AREVA Enrichment Services, LLC
Eagle Rock Enrichment Facility
NRC Docket No: 70-7015
License SNM-2015

Subject: License Basis Documents, Revision 4 and Quality Assurance Program Description, Revision 6

Summary of Changes

Figure 4.4-1 **Rev. 4**
Facility Layout With Detention/
Retention/Infiltration Basins
EAGLE ROCK ENRICHMENT FACILITY
ENVIRONMENTAL REPORT

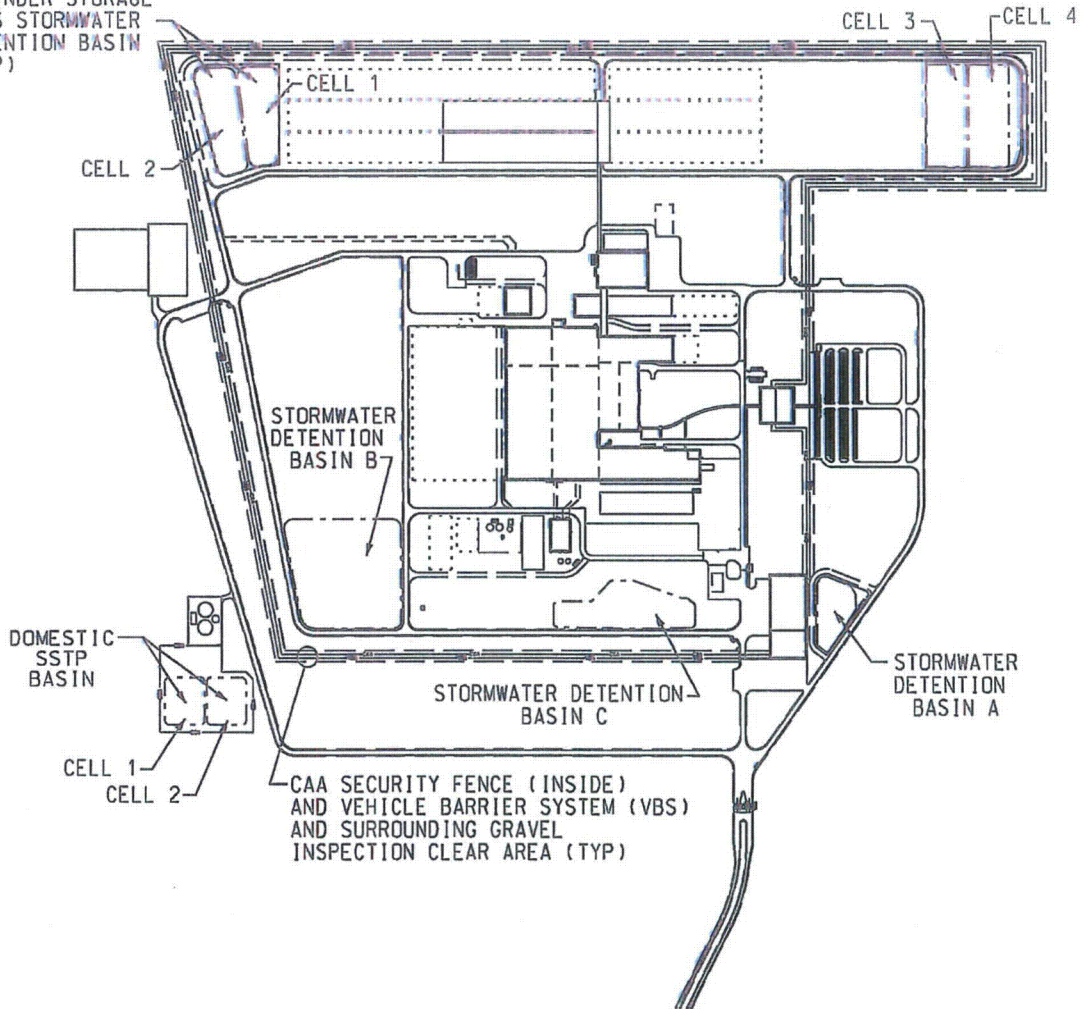
A new retention basin for effluent from the sanitary sewage treatment plant was added to the site plan. This change separates the sanitary sewage treatment plant effluent from the stormwater effluent. This change did not affect the ISA consequence analysis nor the criticality and chemical hazard analysis. The impact to the ISA was a change in the site plan figures.

The stormwater retention basin was split into three basins and each basin was located closer to the source of the stormwater runoff. This change along with the site layout changes resulted in less acreage needing stormwater runoff. Each basin will be monitored for radiological and chemical constituents consistent with the current sampling plan. This change did not affect the ISA consequence analysis nor the criticality and chemical hazard analysis. The impact to the ISA was a change in the site plan figures.

Figure 4.12-1 **Rev. 4**

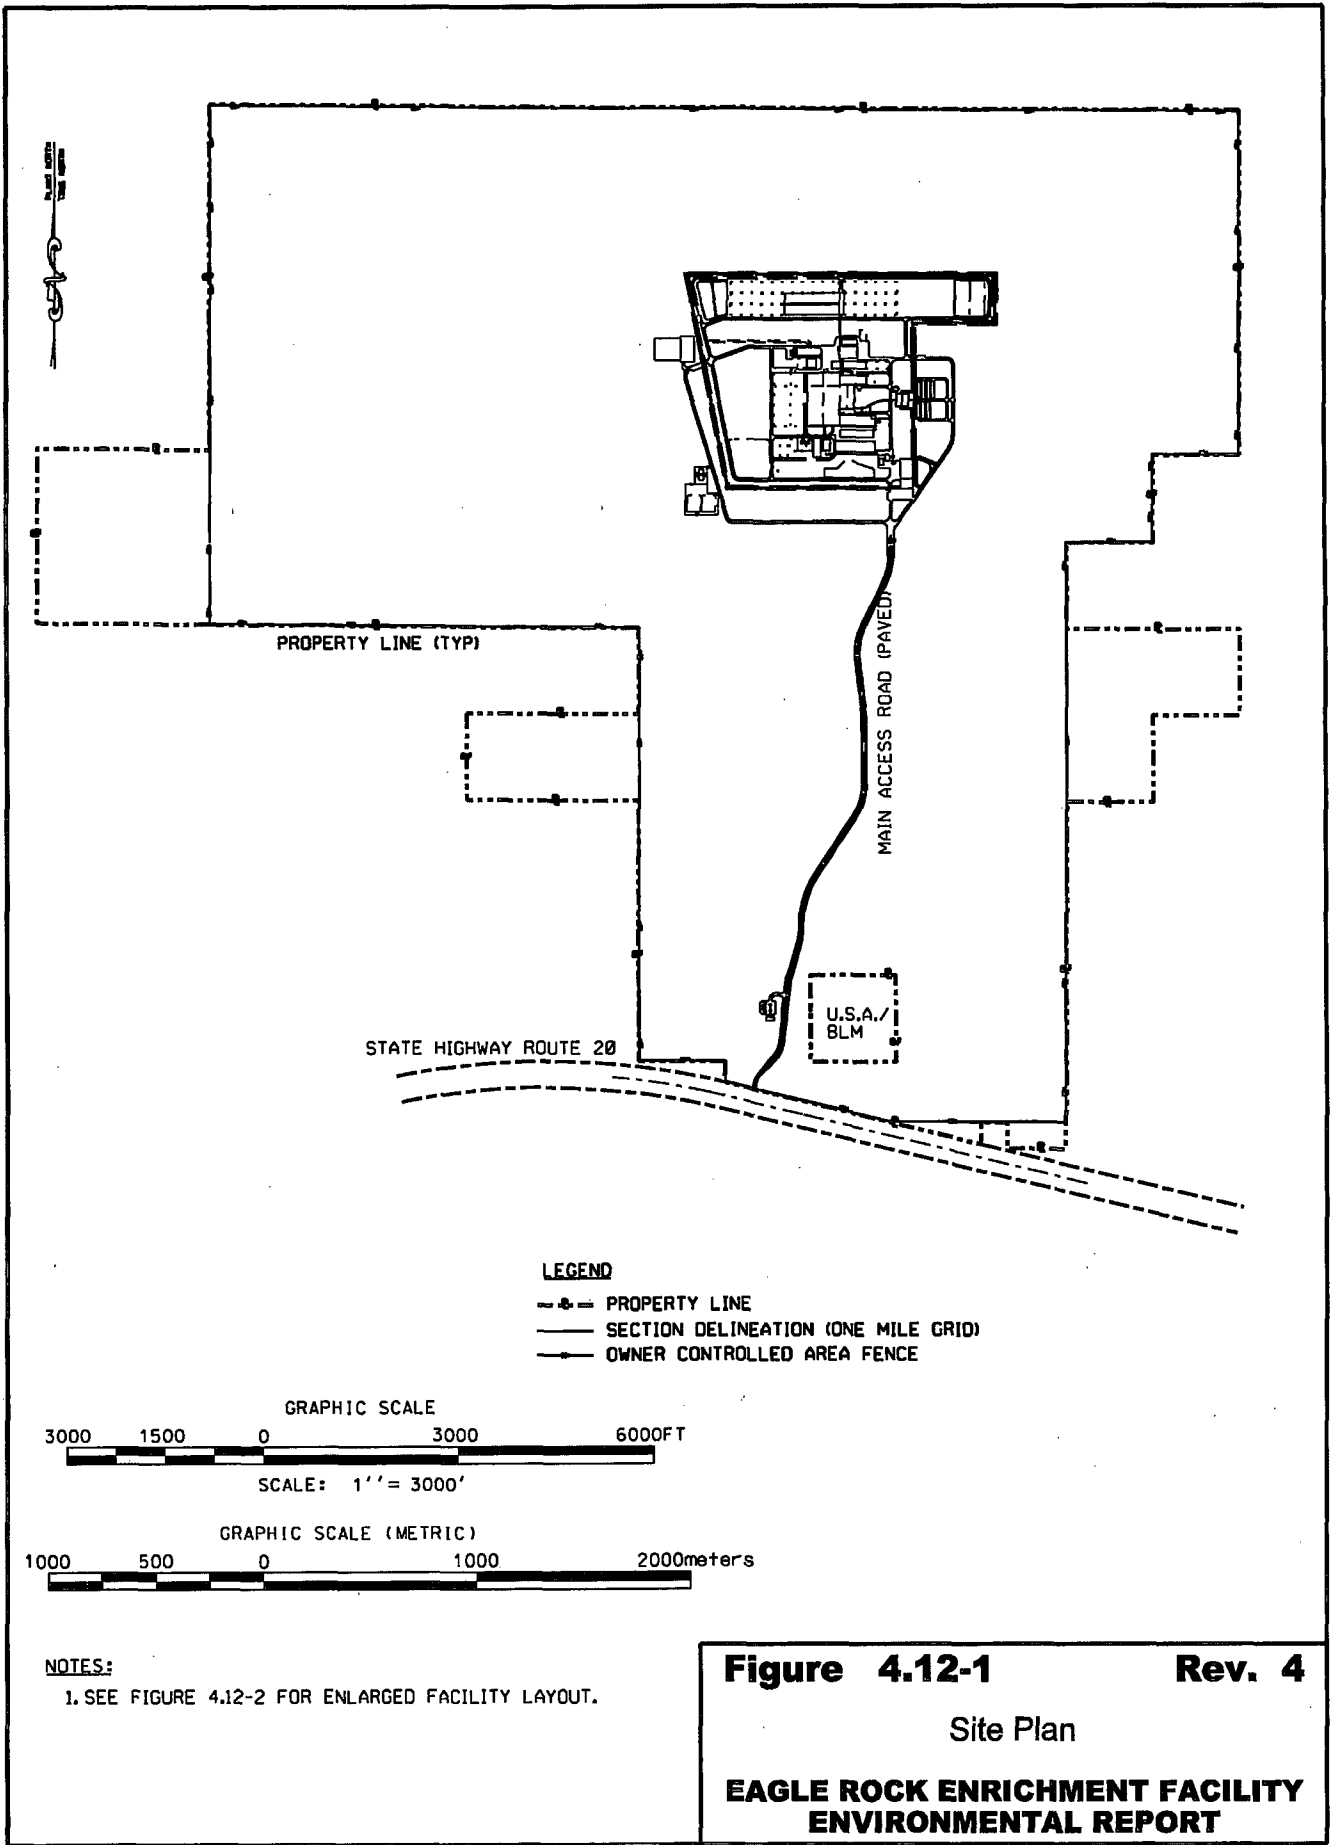
The site plan was revised by shifting the Administration and Security and Secure Administration Building and parking lot from the south to the east and combining both buildings into one. This change did not affect the ISA consequence analysis nor the criticality and chemical hazard analysis. The impact to the ISA was a change in the site plan figures and the location of these buildings. The dose to site radiation workers was unaffected and the dose to the public remained at a small fraction of one percent of the allowable dose to the public. Therefore, the relocation of some buildings will affect radiation dose rates on site, but at levels well below 10 CFR 70.61 criteria and under the control of the EREF radiation safety program.

The Cylinder Overpack Storage Pad was relocated closer to the CRSB to facilitate cylinder shipping and storage for those cylinders requiring an overpack. This change did not affect the ISA consequence analysis nor the criticality and chemical hazard analysis. The impact to the ISA was a change in the site plan figures. The dose consequences were the same as described for the site plan building relocation.

4. **Revised Tails, Empty and Feed Cylinder Storage Pads Layout**
